CALIFORNIA COASTAL COMMISSION

STAFF REPORT: REGULAR CALENDAR

1-97-58

Repair 675 lineal feet of timber and asbestos-sheet bulkhead by facing the bulkhead with epoxy-coated steel interlocking sheet pile armor and backfilling the space

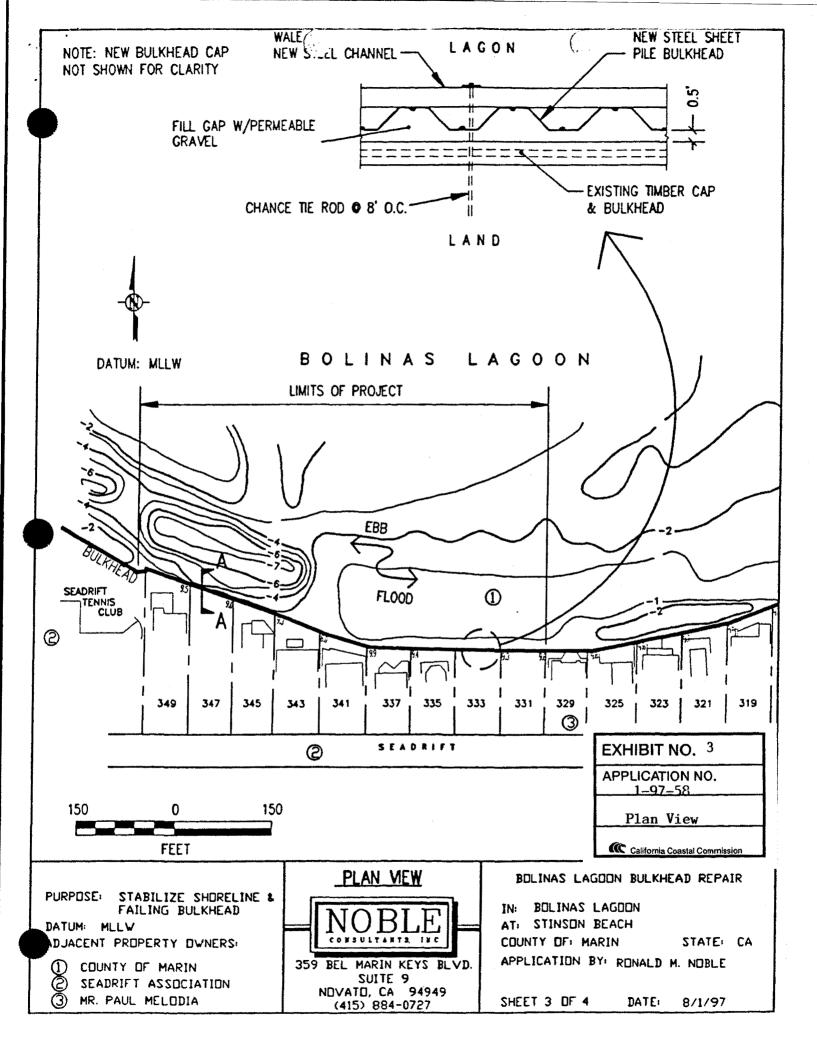
The proposed development site encompasses the Bolinas Lagoon shoreline of nine residential parcels and a portion of the adjacent Seadrift Beach & Tennis Club, near the west end of the Seadrift spit, in Stinson Beach, Marin County. See Exhibits 1-3. The applicant propose to repair 675 lineal feet of timber and asbestos—sheet shoreline bulkhead by facing the bulkhead with epoxy—coated steel interlocking sheet pile armor and backfilling the space behind the armor sheets with gravel. The lagoon bottom area that would be displaced by the project consists of 675 square feet of unvegetated fine to medium sands directly in front of the existing bulkhead. Neither the project site nor properties protected by the bulkhead contain any environmentally sensitive habitat areas (ESHAs). See Exhibit 3, Plan View, and Exhibit 4, Section View.

The proposed project consists of installing a new bulkhead directly in front of the failing bulkhead. The new bulkhead would consist of steel interlocking sheet piles, factory-coated with an epoxy protective substance, driven to a depth of -21 to -27 feet MLLW. The bulkhead would be anchored near its top by tie rods, connected to the steel sheet piles by a double steel channel wale spanning the length of the bulkhead. These 40-foot-long tie rods would be attached to the wale at eight feet on centers, and, for lateral anchor support, be tied to buried helical anchors, driven into the soil behind the bulkhead (Exhibits 3 and 4).

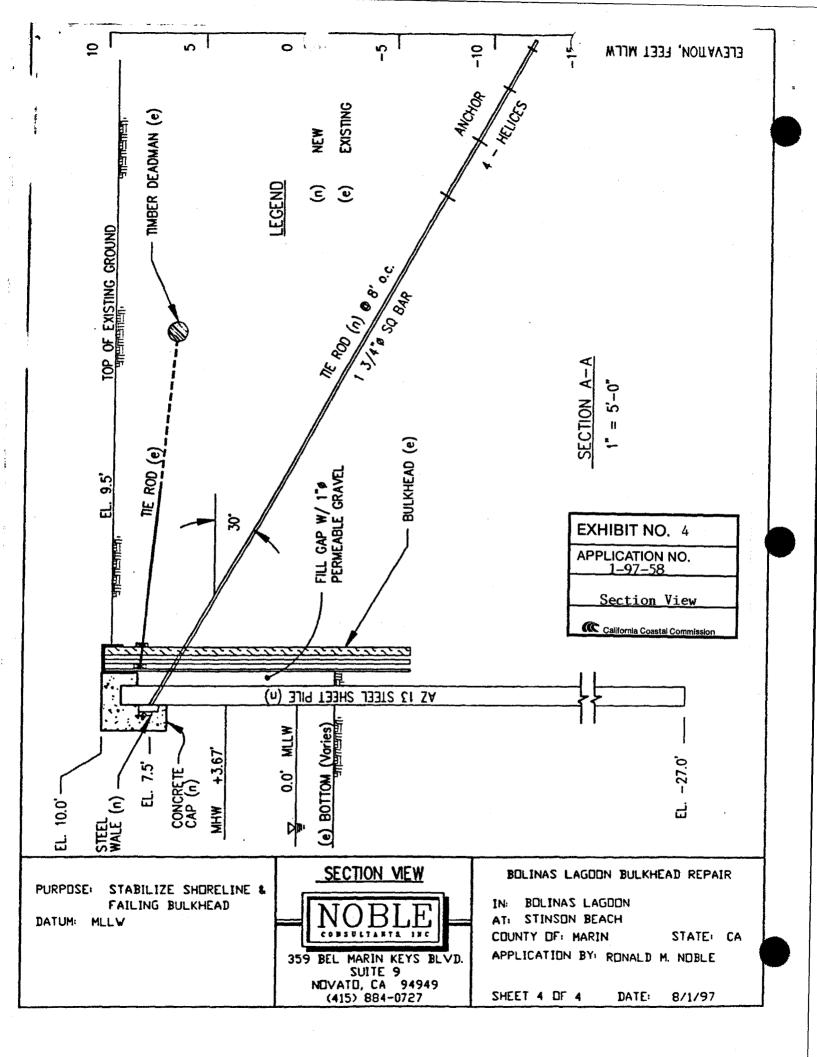
The existing bulkhead consists of a corrugated asbestos sheet pile wall that is anchored by a timber waler, timber cap, and steel rod and steel cable tie rods that are secured to horizontally placed timber pile deadmen buried behind

the bulkhead (<u>Exhibit 4</u>). The bulkhead structure has a maximum height of about 9.5 feet above Mean Lower Low Water (MLLW), or about 5.83 feet above Mean High Water (MHW). See <u>Exhibit 4</u>. The toe depth of both the asbestos and timber sheet piling does not extend below elevation -6 feet MLLW, and in some cases may not extend to this depth.
